**BIDDING AND CONTRACT DOCUMENTS  
FOR THE  
BRUNSWICK COUNTY PUBLIC UTILITIES  
NORTHWEST WATER TREATMENT PLANT – CONCENTRATE DISCHARGE PIPELINE**

ADDENDUM NUMBER 2

PROJECT: NORTHWEST WATER TREATMENT PLANT – CONCENTRATE DISCHARGE PIPELINE

ENGINEER: CDM SMITH

PROJECT NO. 250459-232662  
FILE NAME: C-CP-25.dwg  
SHEET NO.  
**C-CP-25**

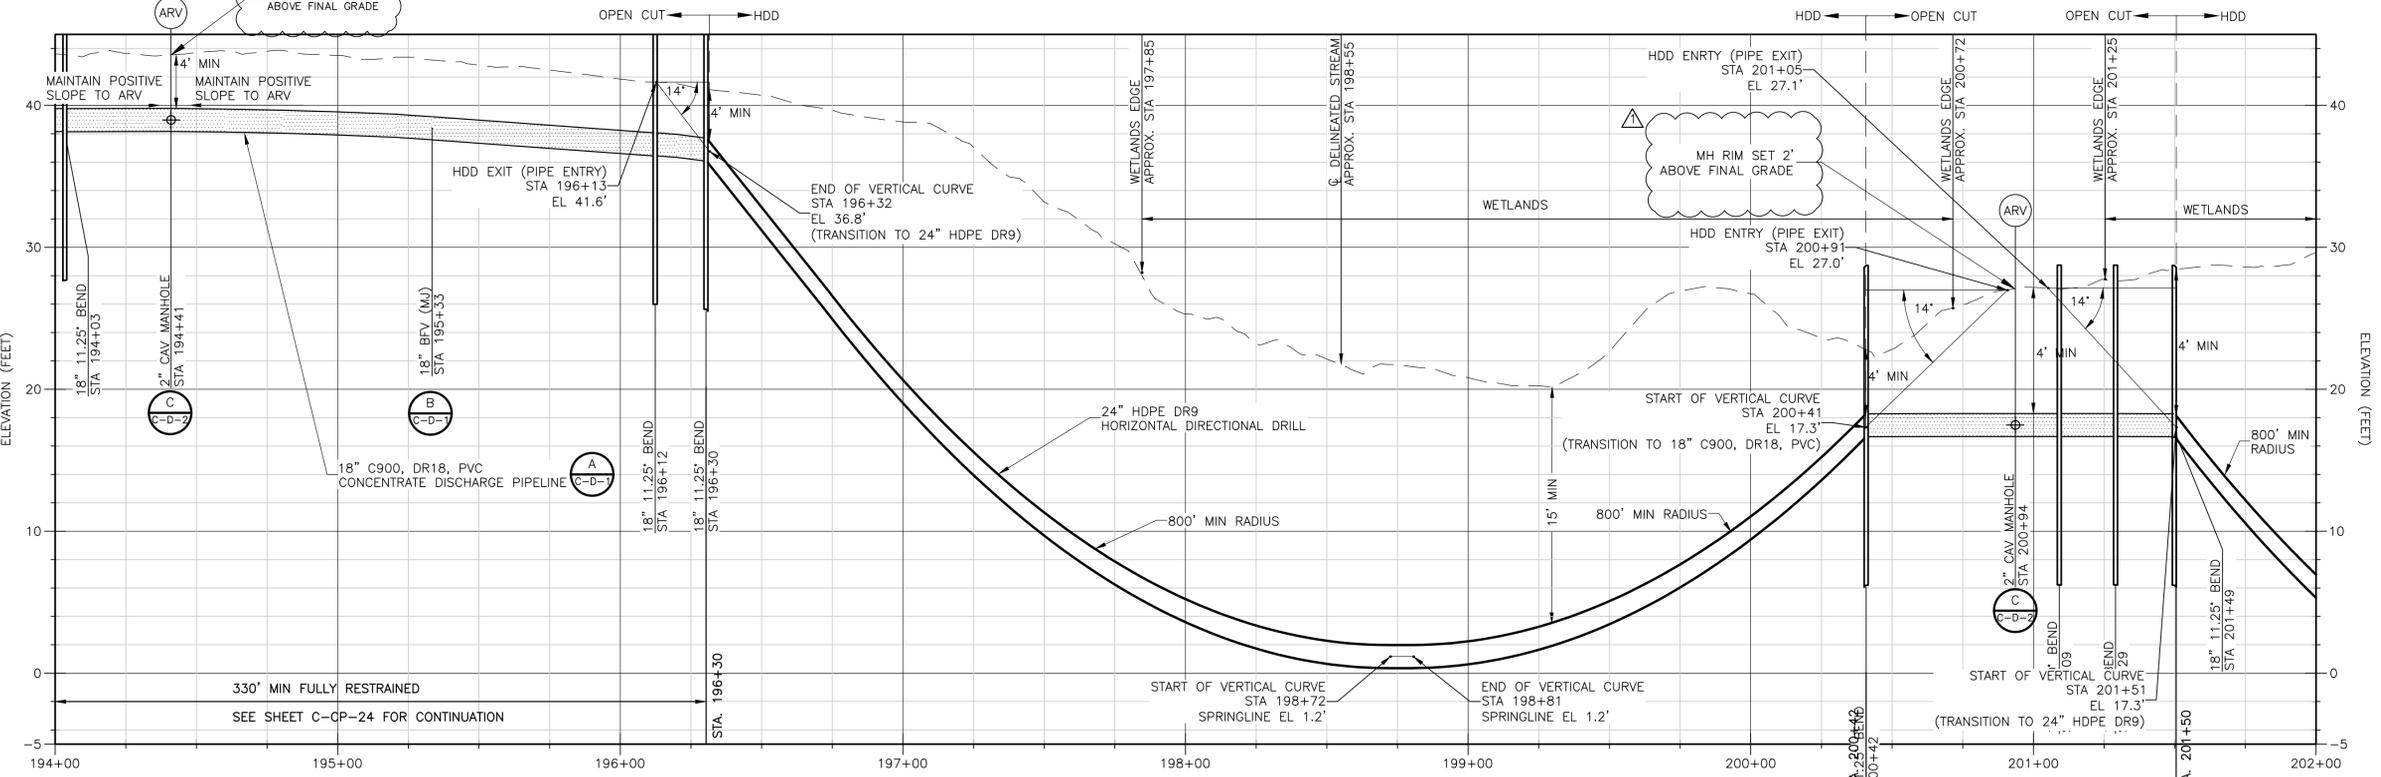
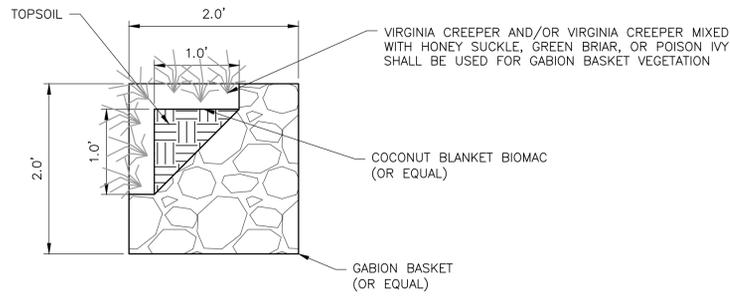
7. The construction entrance to the HDD laydown area on sheet C-CP-25 has been removed.

TRENCH DETAIL  
DETAIL A  
NTS

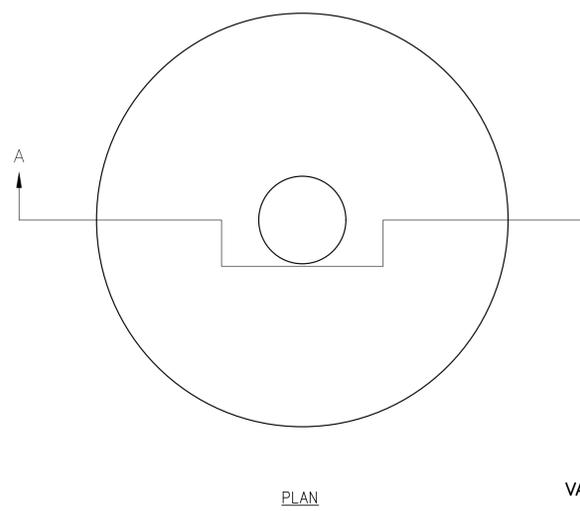
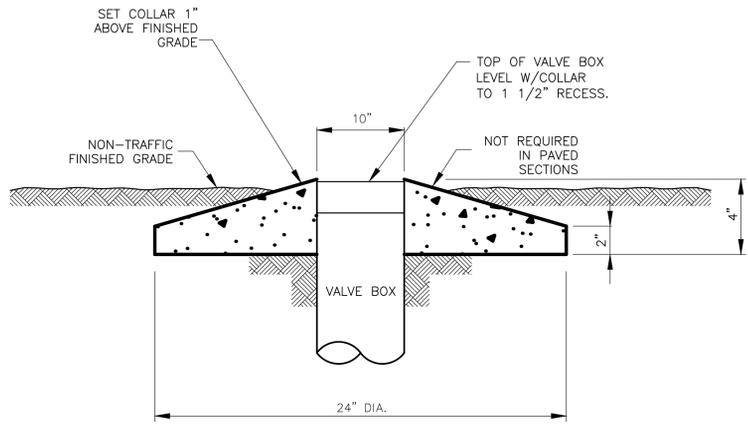
1. Pre-Bid Meeting Sign-In Sheet, Presentation, and Questions/Answers are incorporated into this Addendum as an attachment.
2. Fusible PVC is allowed for all open cut and HDD applications.
3. Pavement repairs include full depth asphalt replacement within the 1:1 pipe trench zone which is measured at the base of the trench and projecting a 1:1 line to ground surface. Pavement repairs outside the 1:1 trench zone include a 1.5" mill and overlay. Refer to the note on detail E, Sheet C-D-1.
